BRESSI GARAGE

CERTIFICATE OF APPROVAL | 02.22.2023

RESPONSE TO ARC BRIEFING COMMENTS - 12/16/2022

West Facade Arc CofA Photomontage View (shown with TBD sign + flush massing + metal panel update)

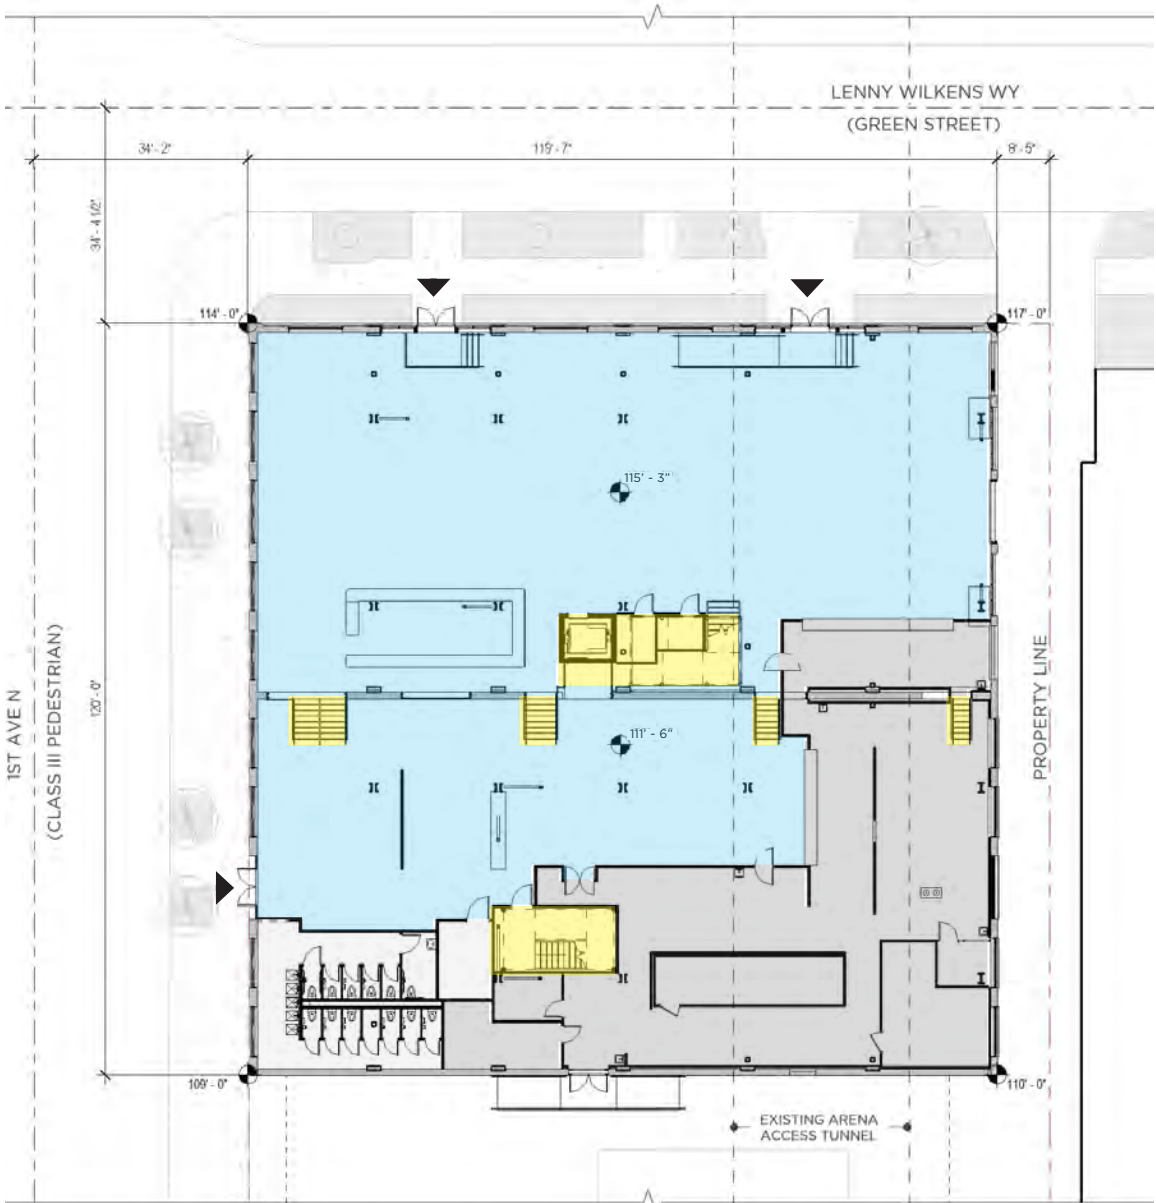
Comment: Horizontal Corrugated Panel
Staff was concerned about the reflectivity and lighter color of the corrugated panel proposed to visually separate the level 2 addition from the existing structure, particularly along Lenny Wilkens Way and the view from Climate Pledge Arena.

Staff requested we further study this finish, to ensure a seamless transition that protects the integrity of the historic structure while reducing the visual mass of the addition.

Comment: South Facade Parapet Height
Staff understood the rationale for the proposed simplification of the parapet lines with the latest update, particularly as it pertains to the south facade wall height. However, staff also requested exploration to see if an elevated parapet to highlight the south facade aligned with the updated design.

Response:
We have adjusted the visual representation of the proposed finish for the horizontal corrugated metal panel to better align with the proposed actual finish demonstrated on pages 23-30, which aligns with staff comments.

The proposed panel will be a factory powder coat in a matte finish, to provide a visual separation while complementing the existing structure and the proposed addition, better aligning with the existing roof membrane material and reducing the visual impact of this material from Climate Pledge Arena and along Lenny Wilkens Way.

Response:
We believe the proposed solution aligns with the staff-supported design intent to treat the entire level 2 addition as a visual object, well defined and articulated to reduce the visual appearance of the mass, while also aesthetically different from the existing historic facade. Keeping the parapet heights consistent will allow the mural wall that celebrates the historic nature of the Bressi Garage to remain as the visual focus, while also balancing and simplifying the presence of the proposed addition to preserve the historic pedestrian experience while celebrating the new use as a community asset.
